SUBJECT: Oral Report by Bell Telephone
Laboratories on the Addition
of 4-Wire Circuits To The
Operational Intercommunication
System at KSC
Case 320

DATE: May 15, 1967

FROM: J. J. Hibbert
G. H. Speake

MEMORANDUM FOR FILE

FIGURE 2 - MODIFICATION FOR TWO 4-WIRE CIRCUITS

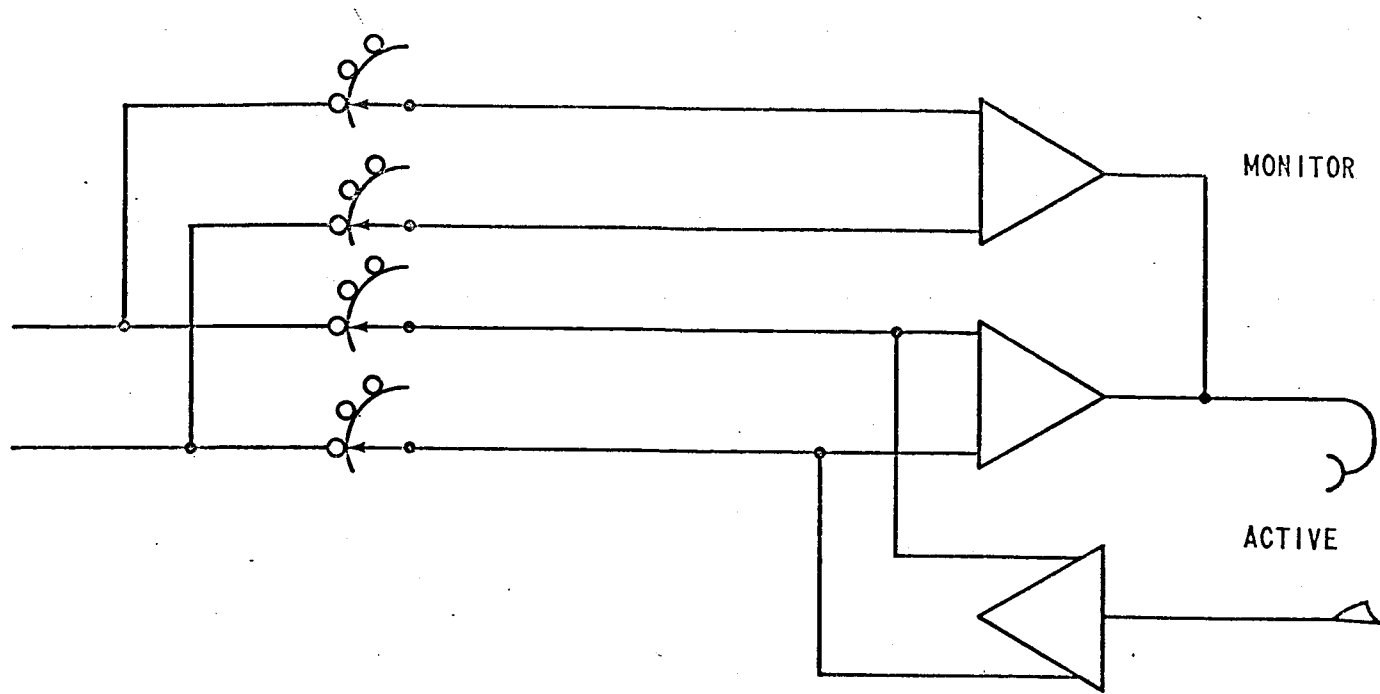
Mr. Michael reviewed a method of adding either one or more 4-wire circuits to the existing 2-wire OIS(A) system. This change would eliminate the use of Voice Operated Switches (VOX) in the conference loops and prevent the occurrence of (1) "echoes" (2) "lockup" (3) "double talking" which have been noted in these circuits previously. The method (described in detail in the attached Appendix) employs relays in the present OIS terminal units to switch from the 2-wire mode employed for most of the loops to the 4-wire mode for 1 or 2 loops. When the user turns to the 4-wire loop, the switch connection activates relays which connect the 4-wire circuits to the headset. The design of the 4-wire system is a so-called "busbar" design with a low characteristic impedance of the order of 1 ohm. Diagrams of this 4-wire modification are shown in Figures 2 and 3.

RELATIVE RESPONSE OF NASA HEADSET RECEIVERS

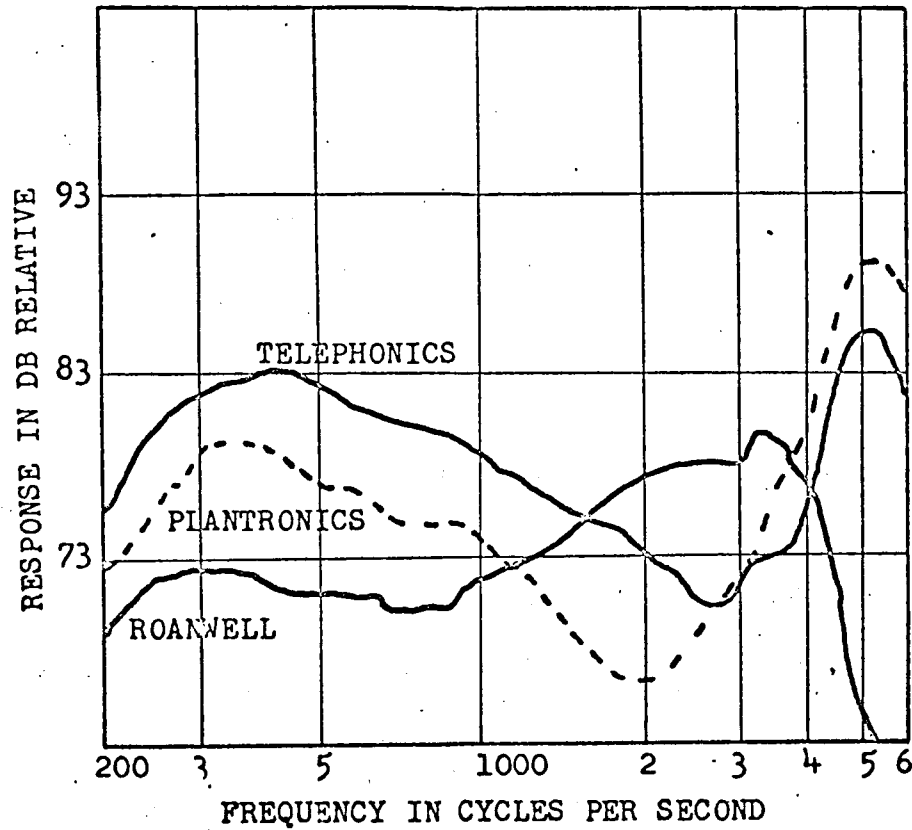
1. Receivers: Fig. 1 shows the frequency response of selected receivers. They show two serious deficiencies: a dip between 500 Hz and 3 kHz, and large peaks at 5 to 6 kHz. The dip causes a loss in intelligibility; the peaks add very little to intelligibility and over-emphasize sibilants and plosives, causing listener fatigue. Limited listening tests have indicated that of the two effects, the high frequency peaks are more disturbing.

In general, between 90 to 95% of the sentence intelligibility is contained below 3 kHz. If a wider bandwidth is used to gain naturalness and slight extra articulation it must be coupled with a smooth, wide dynamic range transmission system. In the expected use, the wider undulating bandwidth of present receivers emphasizes noise and distortion without improving level or intelligibility. The performance would be improved if new transducers were employed with a flat bandwidth from (about) 200 c/s to 3200 c/s. As shown in Fig. 2, transducers with this response are well within present design capability. There is some evidence that the jagged frequency response of present units may be a consequence of the ability to work at low pressures, up to 35,000 feet of altitude.

RELATIVE RESPONSE OF NASA HEADSET TRANSMITTERS

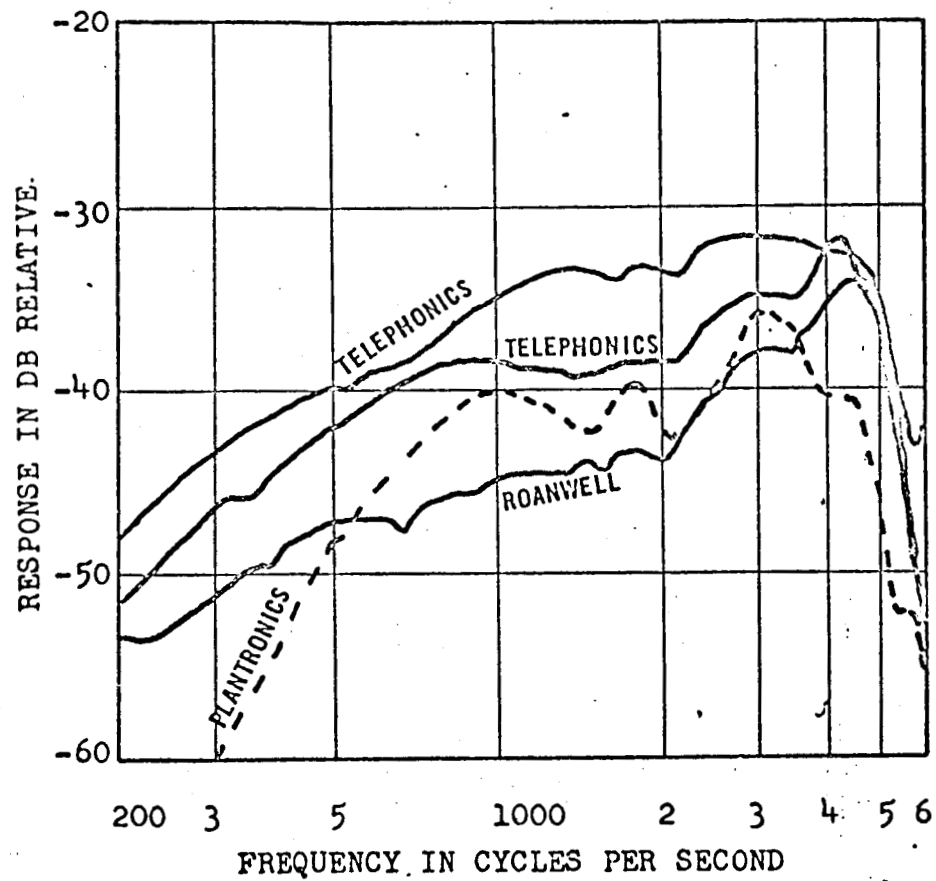
2. Microphones: Frequency measurements on the dynamic noise cancellation microphones are shown in Fig. 3. They all show a rising characteristic from (roughly) 200 Hz to 5 kHz. This is usual in such microphones for much the same reason as pre-emphasis is employed in the record industry; to gain

The microphones tested were deficient in two ways: in output level and in variation from unit to unit. A spread of 10 dB was observed among the 4 noise cancellation samples, and all were several (10-30) dB below other dynamic units available. Some of this is due to noise cancellation, as discussed below.

Because of the large number of users, amplifier noise can be significant with very low level microphones. The signal to noise ratio can be improved if more efficient units are employed. As shown in Fig. 5, a physically interchangeable microphone is available with 10 - 15 dB more gain than the lowest level KSC unit tested.

FIG 1

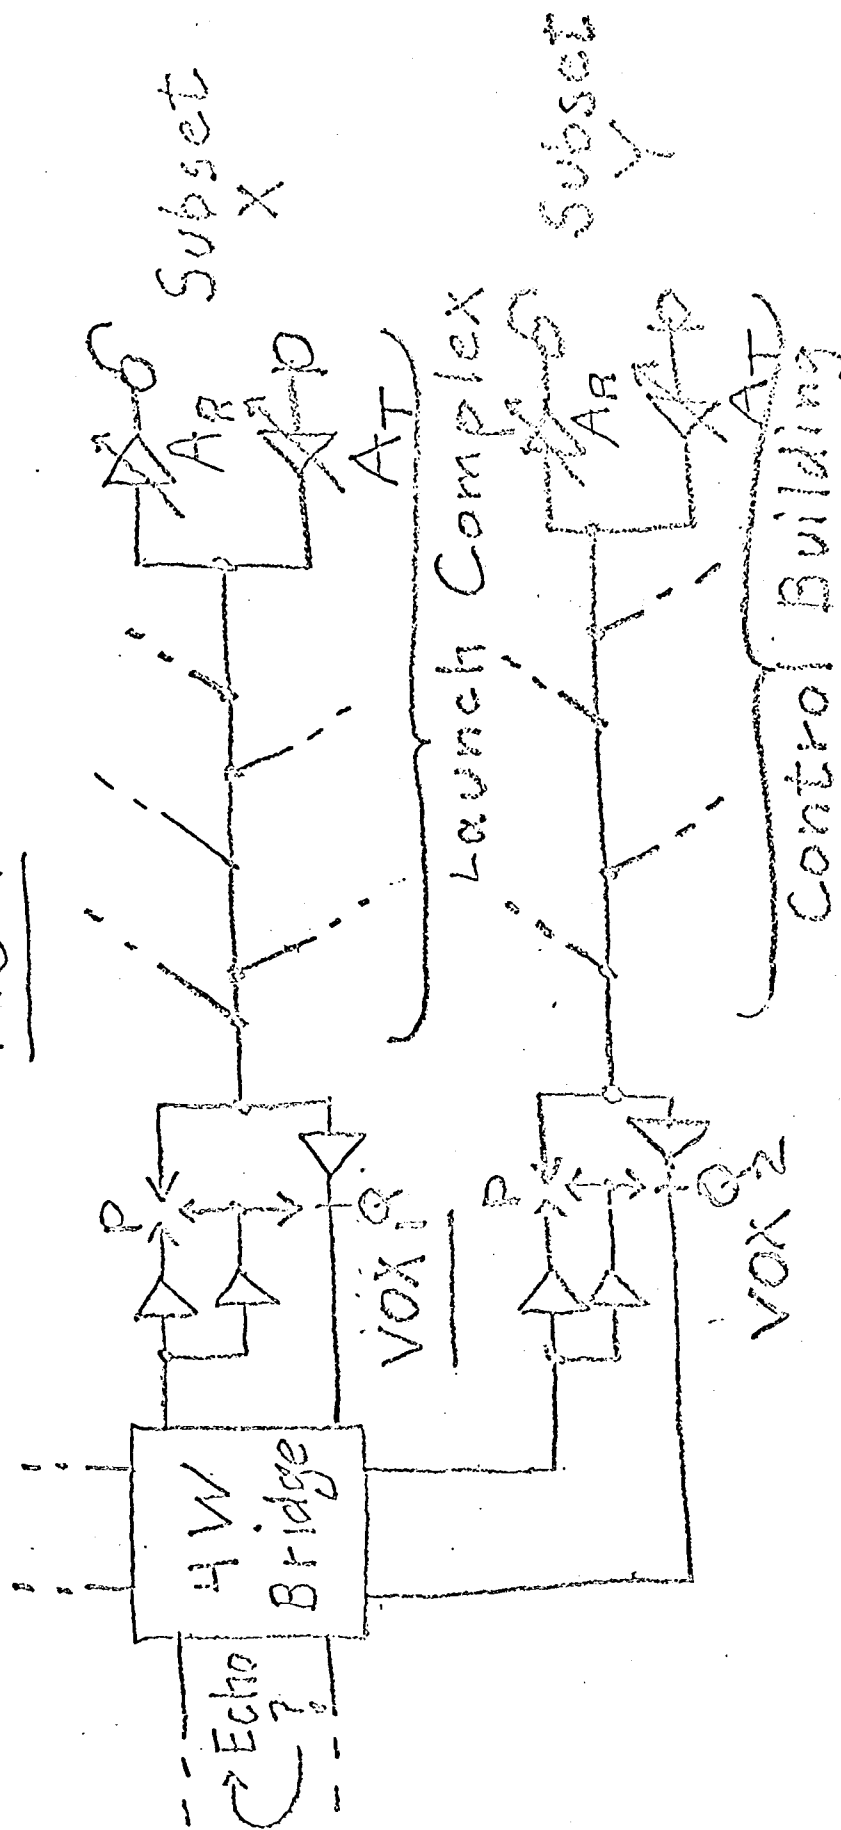
In the discussion, Mr. Mitchell first briefly outlined operation of the voice switching arrangements known as VOX in the present system. This is shown in Figure 1. It was pointed out that this type of voice switching is subject to four basic difficulties which can occur under circumstances of improper usage or high noise.

The first is clipping of weaker portions of speech if someone talks too weakly. The second is false operation of the control P by echo if any echo exists in the line as indicated. This results in severe mutilation of speech, making it essentially unintelligible. The third difficulty can occur due to noise, for instance, from subset X, which can effectively lock up VOX 2, thus preventing any one on the control building setup from getting out. A fourth difficulty occurs if someone on the launch complex talks at the same time as someone at the control tower. In this case only one can get through at a time, and it is actually possible for speech to occur for several seconds without either one realizing that two people are talking. Those present agreed that these were serious difficulties and that the VOX should be eliminated.
